Subject: **Bid #: 8718-W6, Parking Lot Reconstruction – 25 Meade Street / DPF**

ADDENDUM NO. 1

2 PAVING DETAIL
3" = 1'-0"

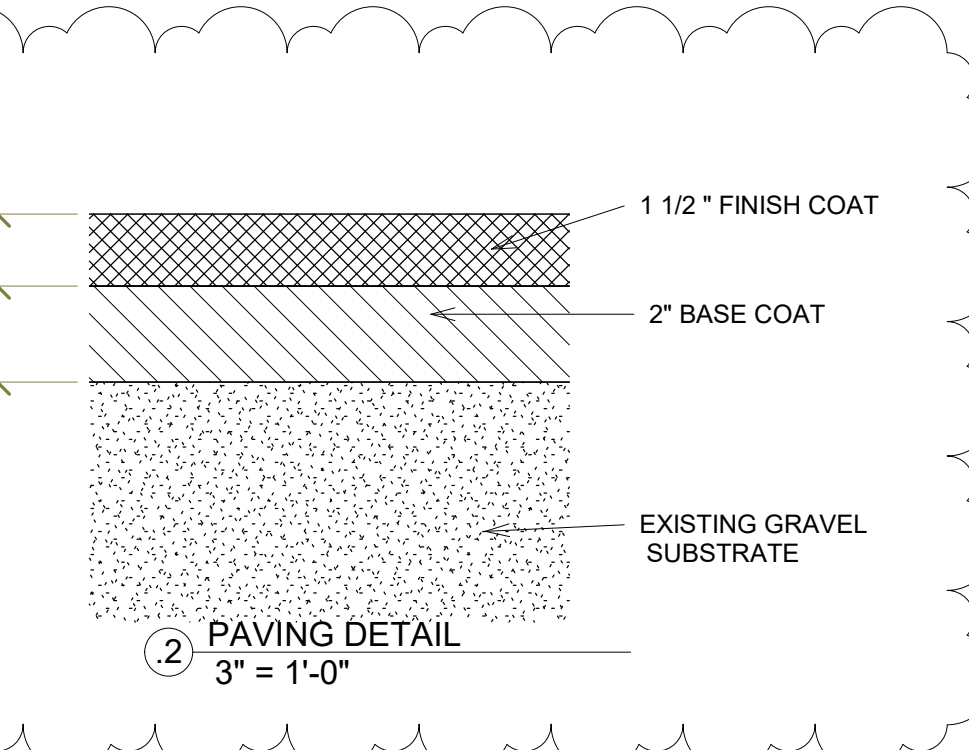
APPROXIMATE AREA OF PAVING
18,065 SQ FT (VERIFY)

1 PAVING PLAN
1" = 10'-0"

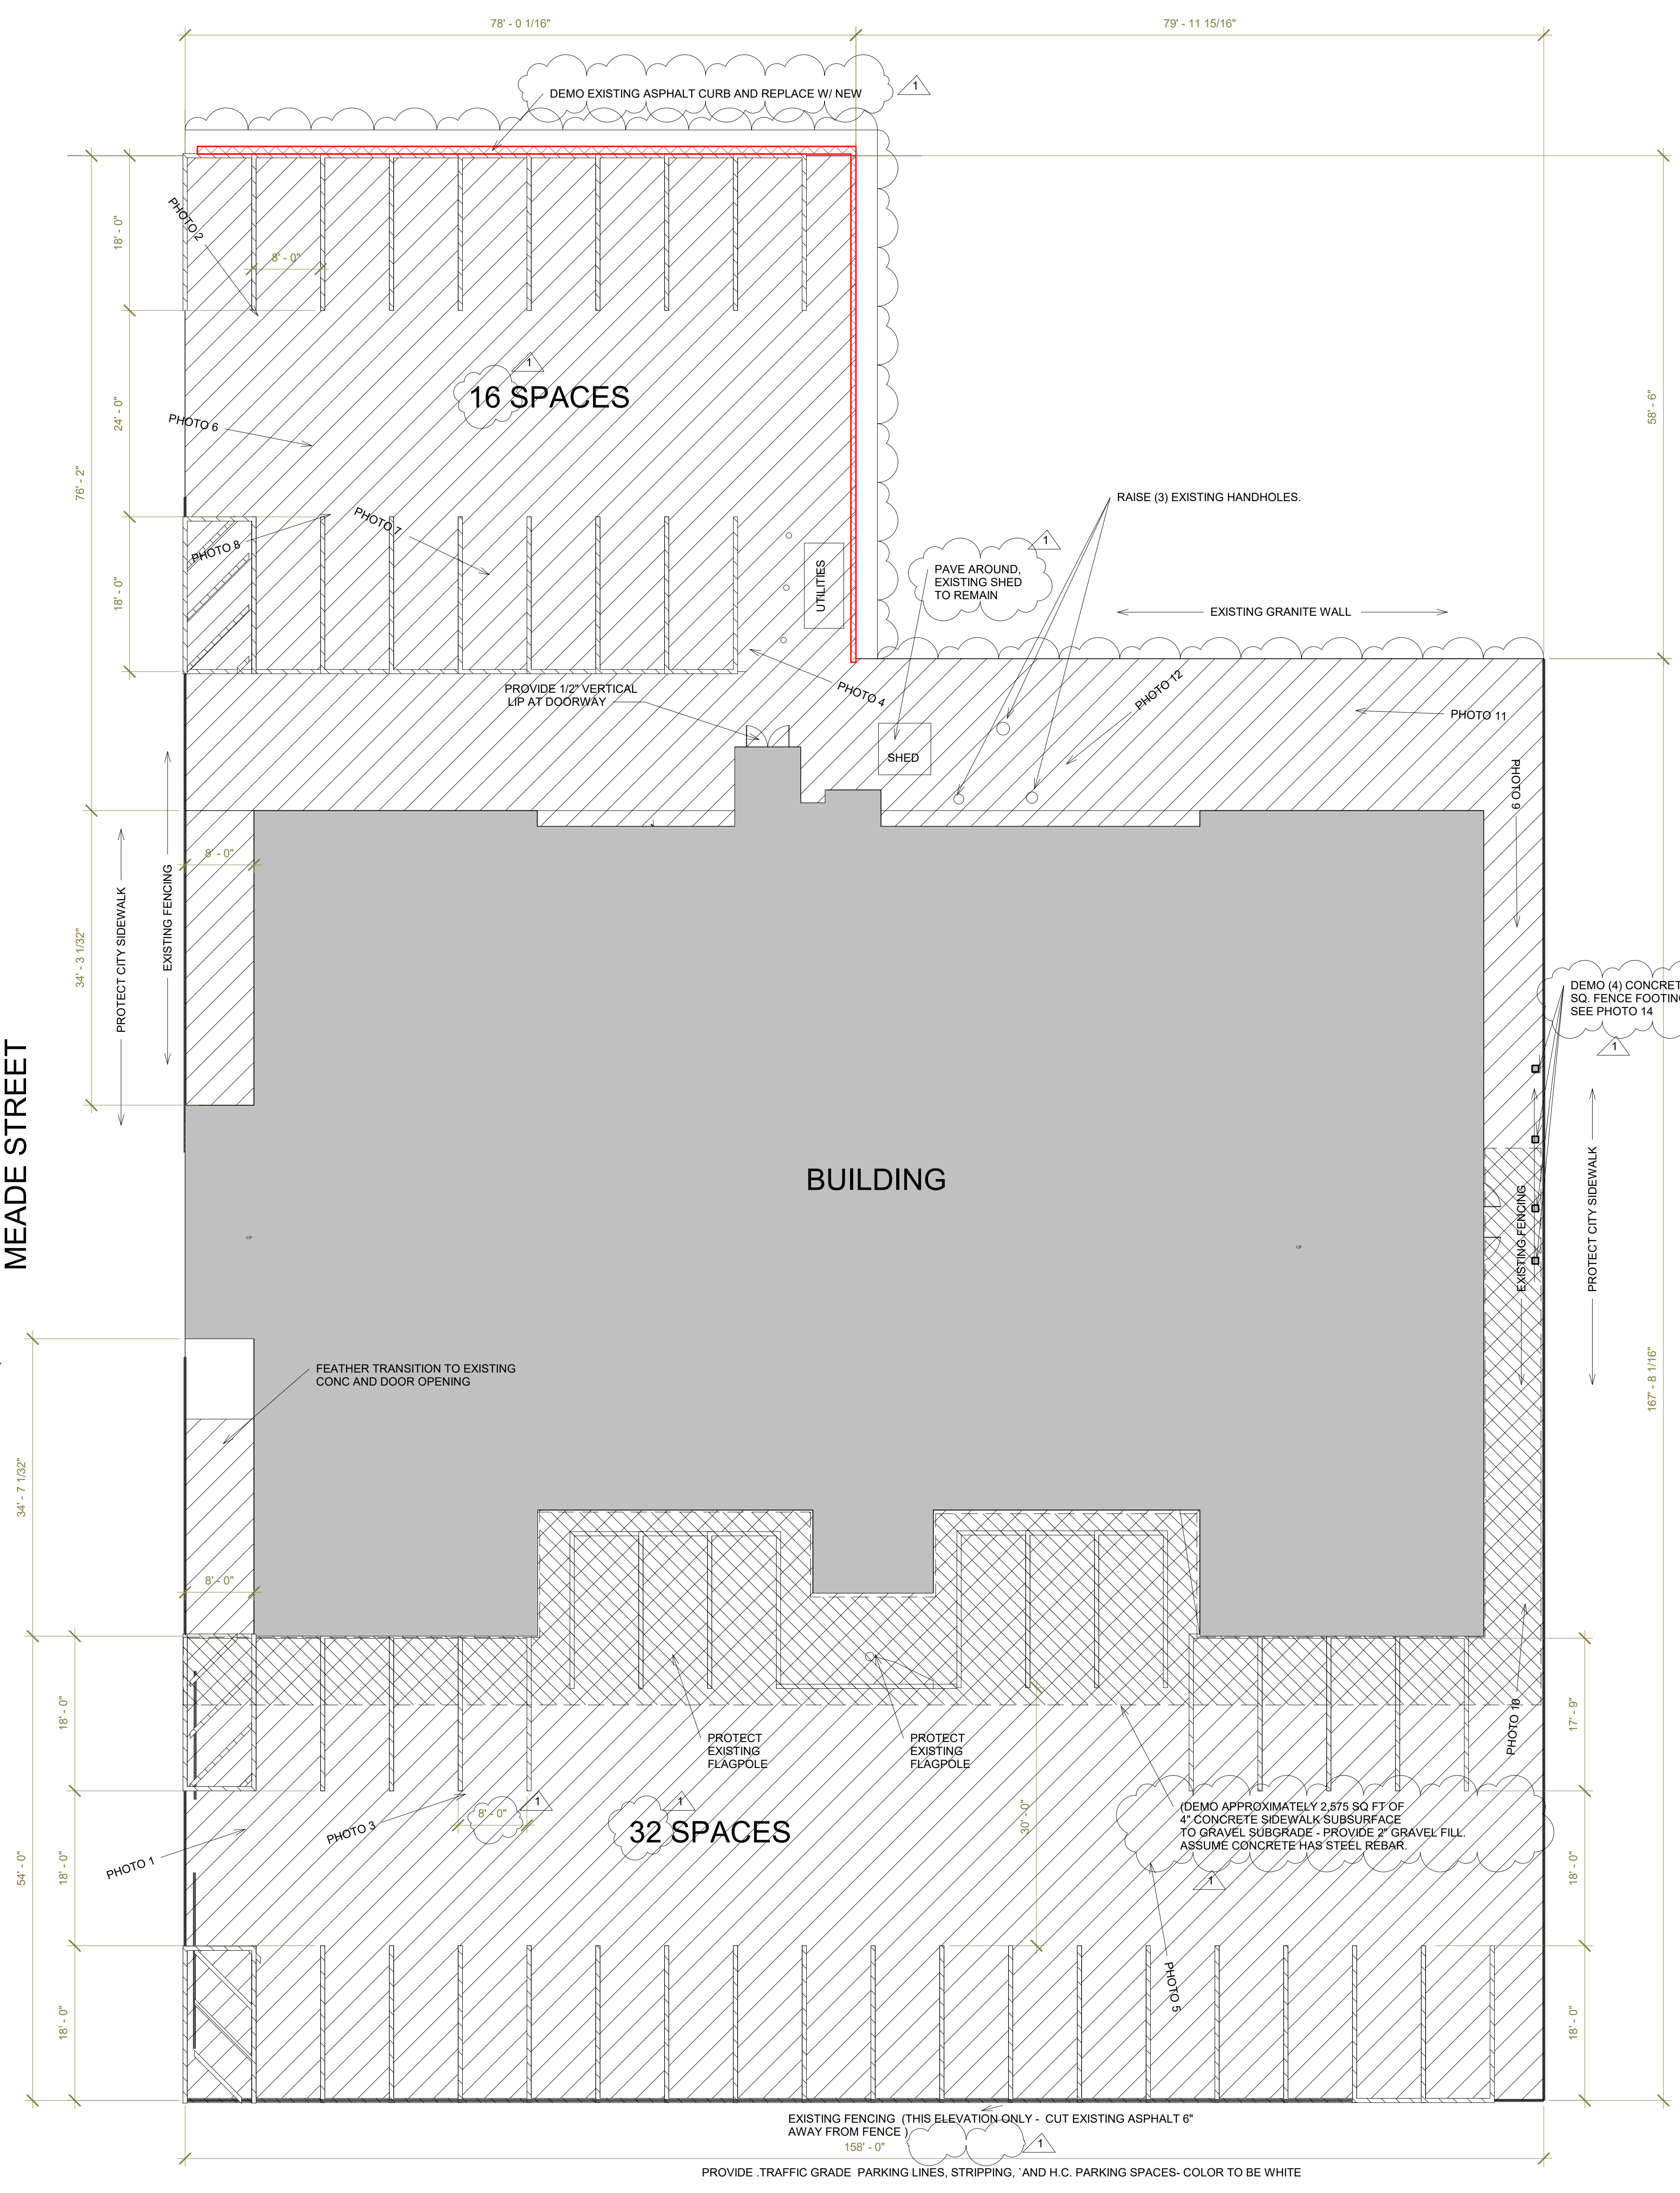
1. Demo (4) concrete square fence footings, see plan and photo 14.
2. Demo existing asphalt curb and replace with new at Southern portion of parking lot.

1. Provide a full depth removal of existing hatched areas of asphalt paving and any concrete sidewalk subsurface below to existing gravel substrates. Provide 2" gravel fill at areas of remove concrete sidewalk. Assume concrete has steel rebar.
2. Remove cutting of chain link fence. Handwork asphalt paving below.
3. Reduce parking spaces from 9' wide to 8' wide.
4. Pave around existing shed at South elevation, the existing shed to remain in place.
5. One week completion time frame change to contractor having one week work increments noted on drawing.

FULL DEPTH REMOVAL OF EXISTING PATCH AREAS OF ASPHALT PAVING AND ANY CONCRETE SIDE SURFACE BELOW TO EXISTING GRAVEL SUBSTRATES. RECOMPACT AND PROVIDE NEW ASPHALT PAVING. MAINTAIN EXISTING SLOPES AWAY FROM BUILDING.

PHOTO 14
DEMO (4) CONCRETE SQ FENCE FOOTINGS

FENCE SCOPE OF WORK REMOVED (HANDWORK ASPHALT PAVING UNDER AREAS OF FENCE AND ALIGN W/ EXISTING ADJACENT SIDEWALK.
